Access Compliance Report

Public Rights-of-Way

Intersection ID: 17596	Main Street: WATER_OAK_RD	Cross Street: N_SHARON_AMITY_RD	Location: NW
ADA ID: 1B49181F0EA3	Ramp Type: PerpDiag	Initial Pass/Fail: Fail	Overall Compliance: No
		Severity Score: 12.5

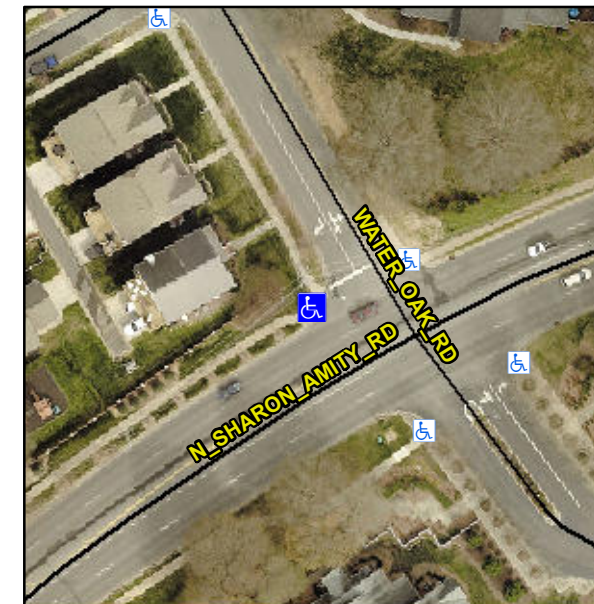
R304.5.3

Compliance	Description	Data	Compliance	Description	Data
N/A	Ramp Length (in)	60.0	Yes	Ramp Slope (%)	5.4
Yes	Ramp Width (in)	48.0	No	Ramp XSlope (%)	5.3
N/A	Flare Type LT	N/A	N/A	Flare Type RT	N/A
N/A	Flare Slope LT (%)	N/A	N/A	Flare Slope RT (%)	N/A
N/A	Flare Traversable LT?	N/A	N/A	Flare Traversable RT?	N/A
N/A	Landing Length (in)	N/A	N/A	DWS Provided?	N/A
N/A	Landing Width (in)	N/A	N/A	DWS Contrast?	N/A
N/A	Landing Slope (%)	N/A	N/A	DWS Length (in)	N/A
N/A	Landing X Slope (%)	N/A	N/A	DWS Full Width?	N/A
N/A	Landing Curb? (Y/N)	N/A	N/A	DWS Offset (in)	N/A
N/A	Shared Landing?	N/A			
N/A	Gutter Ponding?	N/A	N/A	Gutter Slope (%)	N/A
N/A	Gutter Lip Ht (in)	N/A	N/A	Gutter X Slope (%)	N/A
N/A	Painted X Walk1?	No	N/A	Painted X Walk2?	No
	X Walk 1 Direction	To SE		X Walk 2 Direction	To NE
N/A	X Walk 1 Width (in)	N/A	N/A	X Walk 2 Width (in)	N/A
	X Walk 1 Slope (%)	0.7		X Walk 2 Slope (%)	5.9
	X Walk 1 X Slope (%)	5.4		X Walk 2 X Slope (%)	5.3

Remove & Replace Curb Ramp With Two New Directional Ramps or Equivalent.
